Feedback of 2025 IDRC Review Report

中國科學院高能物理研究所
Institute of High Energy Physics
Chinese Academy of Sciences

Figure 6.21: Charge density in the TPC as a function of radius (average in φ and z direction already) and fitted by an empirical Equation 6.2, (Magenta dashed line in the plots). (a): H mode (b): Low luminosity Z mode.

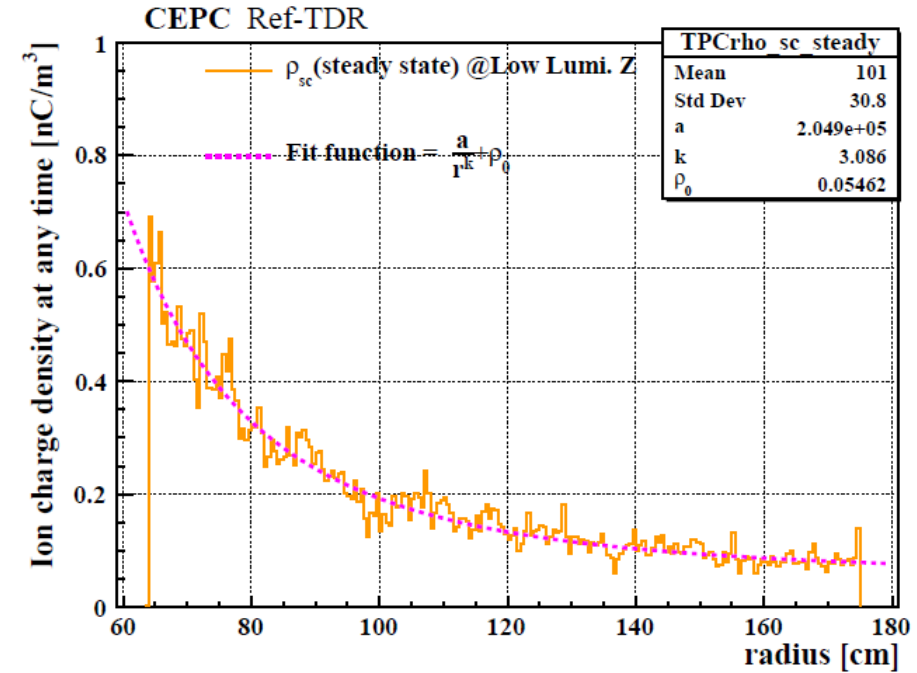
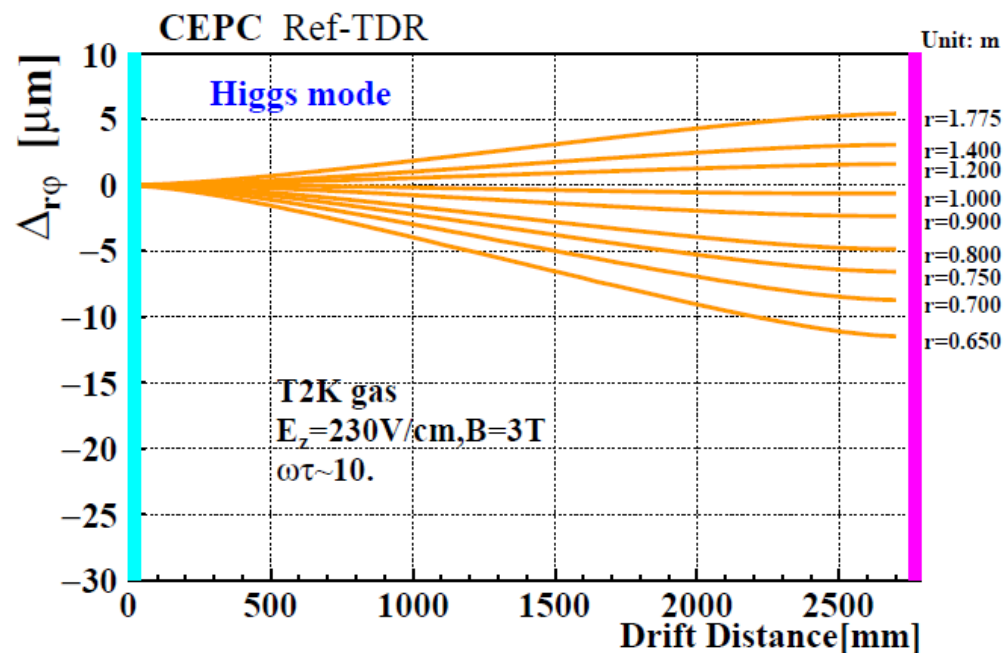
- The chapter still lacks a quantitative description of space-charge distortion and its impact on tracking;
- The description of space-charge distortion and its impact on tracking have been added in the subsection of 6.3.2.4 (TPC space distortions estimation). The detailed R&D of its impact on tracking will do in next steps.
- There is no indication or explanation of how correction strategies (e.g., ALICE-like data-driven approaches) can be implemented, at least qualitatively;
- The brief description of the correction strategies have been added in the subsection (Calibration and alignment).

Figure 6.17: Prototype of the TPC readout detector module. The FEE for a single module has been described in the endplate design.

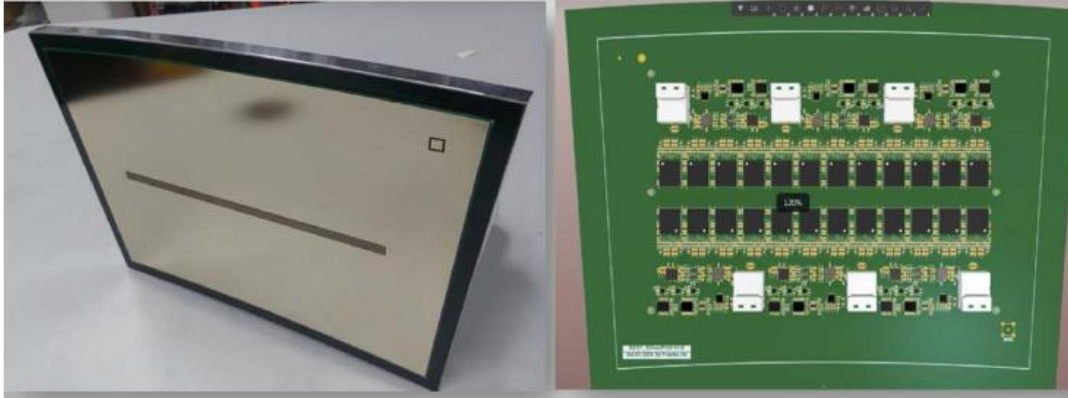
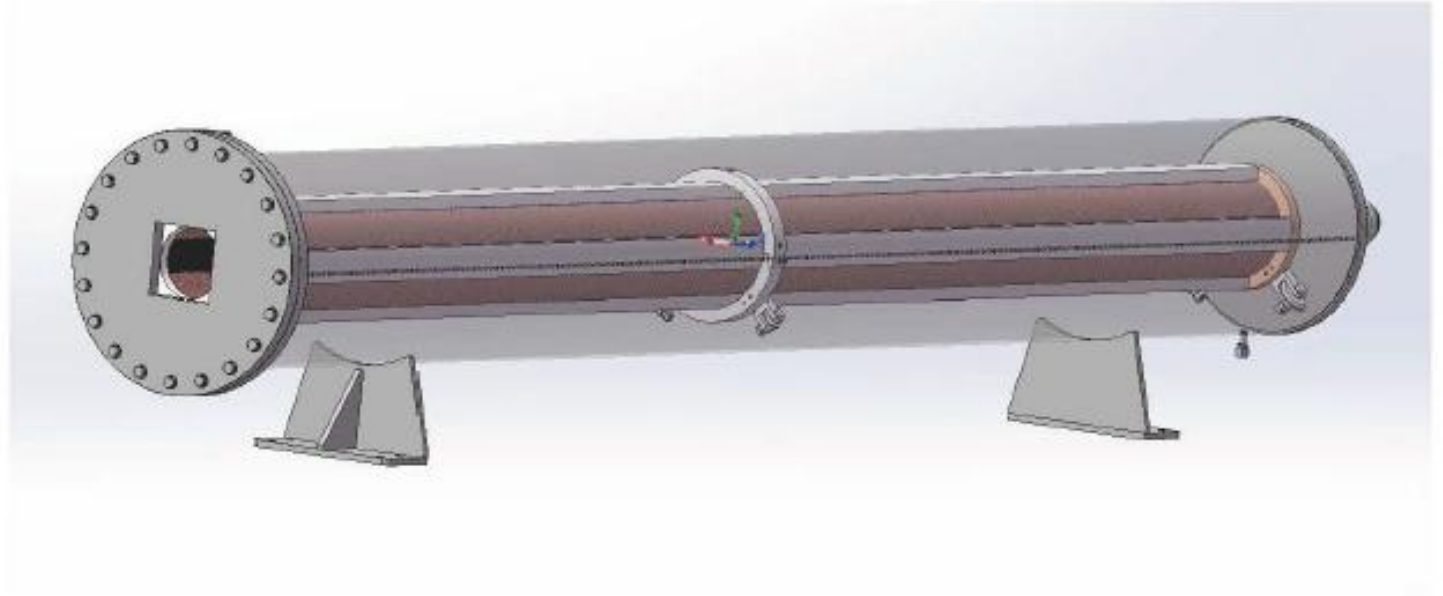
- The choice of the pixel readout chip (TEPIX) with a $500 \times 500 \mu\text{m}^2$ pixel size is currently driven by power consumption considerations. A TPC module prototype with 10×300 readout channels (using 24 TEPIX chips) has been developed and is planned for beam testing at DESY in 2025. Larger prototypes will need to be developed and tested during the EDR phase. Optimization of pad size and gas mixture must be finalized, clearly distinguishing between the digital pixel readout case and the pad readout case. These two approaches lead to distinctly different electronics requirements, particularly regarding the need for analog-to-digital conversion in the pad case.

Using the prototype of TEPIX chip, a 32×32 pixel-array interposer prototype has been developed to integrate the readout TEPIX chips to the charge-collecting pixels (pixel size: $500 \mu\text{m} \times 500 \mu\text{m}$). Figure 6.17 illustrates the prototype of the readout detector module after integration of the Micromegas detector and the FEE. The prototypes developed by the other groups achieved smaller $55 \mu\text{m} \times 55 \mu\text{m}$ granularity[21, 22]. The the total power consumption is excessive and would require a cooling beyond the capacity of a water cooling system.

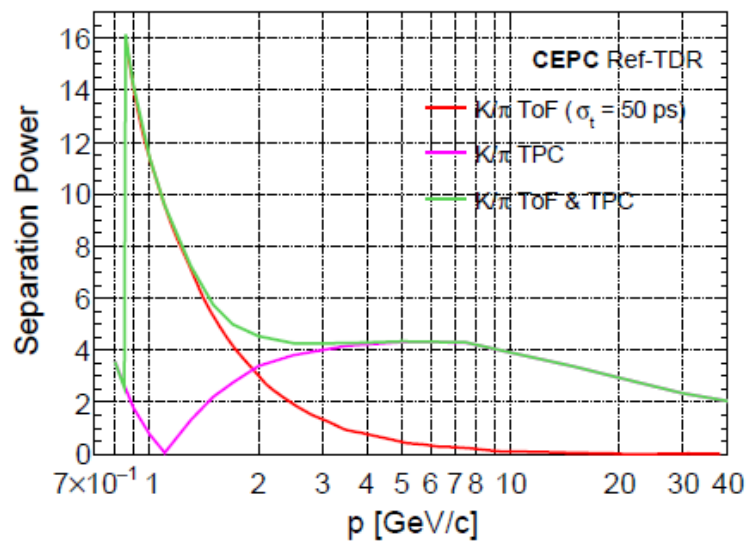
- Performance plots, especially in conjunction with the ITK/VTX system, are missing or remain in a preliminary stage;
- The update description of the performance plots in conjunction with the ITK/VTX system has been added in TDR document.

Figure 8.24: (a) Energy linearity and (b) energy resolution of GS-HCAL with the digitization model.

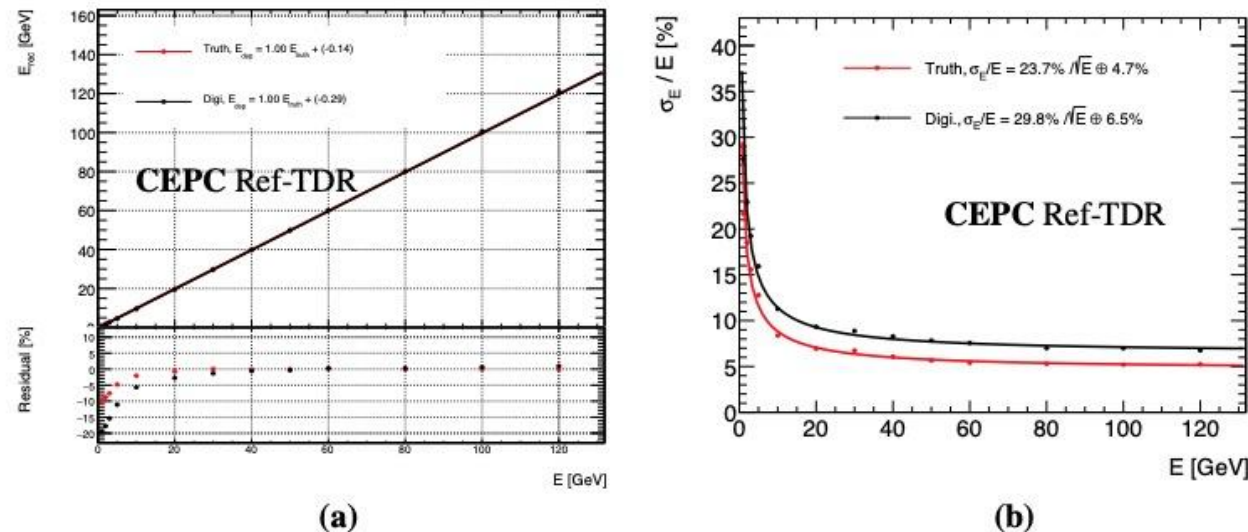
- F-A-8-2: The proposal is reasonable but aggressive. Detector specifications and performance benchmarks are clearly defined; however, considerable work is needed to bring the GS-HCAL baseline choice from its current R&D phase to a full-scale detector.
- --The primary objective of this section is to validate that the GS-HCAL design meets the CEPC physics program's core performance criteria. Leveraging extensive simulation studies in the absence of prototype data, we demonstrate the design's compliance with these requirements. In the new version in **Section 8.5** (simulation and performance).

--As shown in Fig. 8.24, comparing linearity and resolution between with and without digitisation, the linearity does not show a apparent issue, i.e. the leakage, or the hadronic shower longitudinal profile is not expected to depend on the energy of the incident hadrons, e..g.

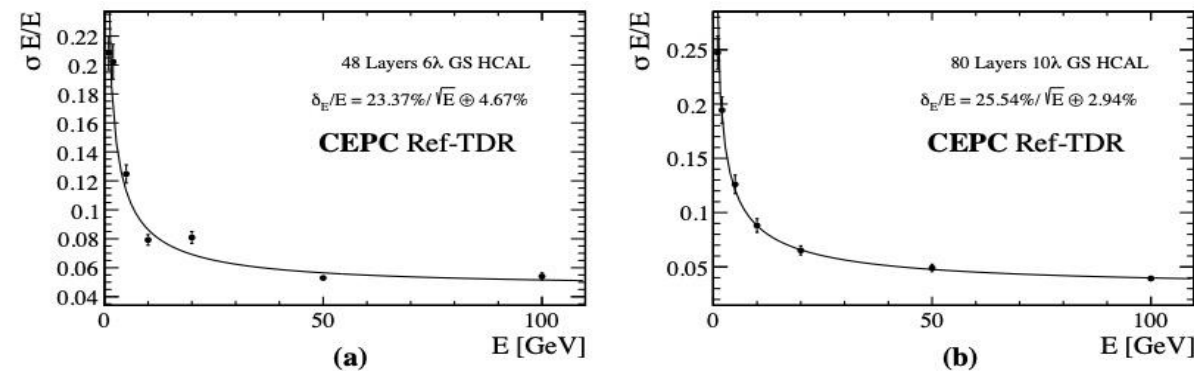
- F-A-8-3: For instance, during the review, the team was uncertain about the origin of the constant term observed in the hadronic energy resolution, a result obtained from idealized simulations with only limited hardware effects included.
- --To verify the hypothesis that longitudinal leakage was the cause of the observed discrepancy, we increased the depth of the GS-HCAL from 48 layers ($6 \lambda_I$) to 80 layers ($10 \lambda_I$) in **Section 8.5.2 Hadron Energy Resolution**. When the calorimeter depth was extended to 80 layers, this tail decreased significantly, and the constant term dropped to around 2.9%. The significant improvement in the constant term upon increasing the depth of the GS-HCAL supported the hypothesis that shower leakage, rather than an intrinsic design flaw.

Figure 8.2: (a) Single layer structure of GS-HCAL. (b) One GS cell.

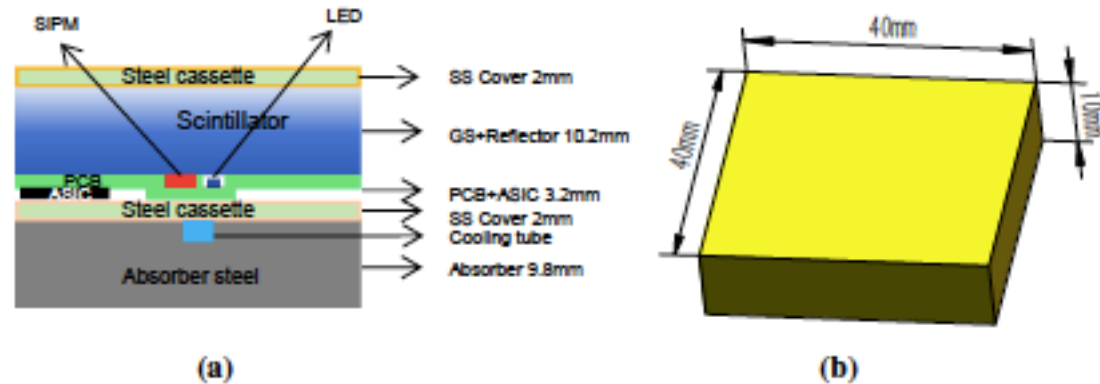
- F-A-8-5: In this prototype, each tile will be read out by four SiPMs, whereas in the final detector only one SiPM per tile is foreseen for cost reasons.
- --It is clear that there is only one SiPM for tile for the design and cost, as show in **Figure 8.2**, and detaied describe could be found in **section 8.2.1** (Single layer structure). In the **Section 8.4.5** (Measurements of GS with SiPM), it is shown the cosmic ray test result of the 4cm*4cm*1cm glass cell coupling with 1 piece of 3mm*3mm SiPM.

Figure 8.12: (a) Transmission and XEL spectra of large GFO glass, (b) Energy spectra of GFO GS and BGO crystal with same dimension. (c) Scintillation decay curve of the GFO glass.

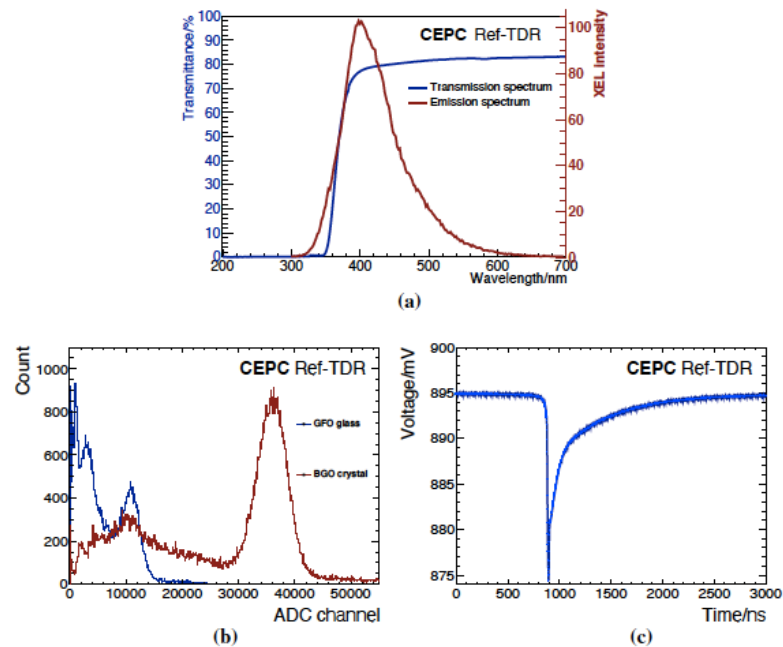
- C-A-8-4: The authors are encouraged to make the text more concise where possible, while still providing sufficient detail where necessary.
 - o C-A-8-4-1: Captions such as that for Fig. 8.12 ("The real AHCAL prototype") are inadequate and should be made more informative.--the outline of the HCAL in new version has changed, this types of pictures were deleted.

--In Fact, in the Section **8.4.2 Glass Scintillator**, the **Figure 8.12**: the transmission and XEL spectra of large GFO glass, the Energy spectra of GFO GS and the Scintillation decay curve of the GFO.
